OUT OF TUNE

Fuzz-Box For Electric Guitar (*February, 1968, page 42*). In Fig. 1, the line between the wiper

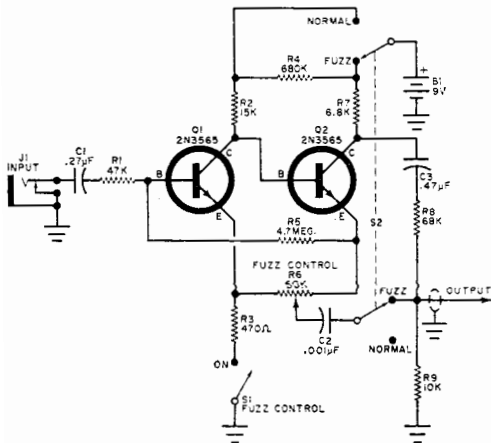
of R_6 and FUZZ/NORMAL switch S_2 should be broken and capacitor C_2 inserted as shown above.
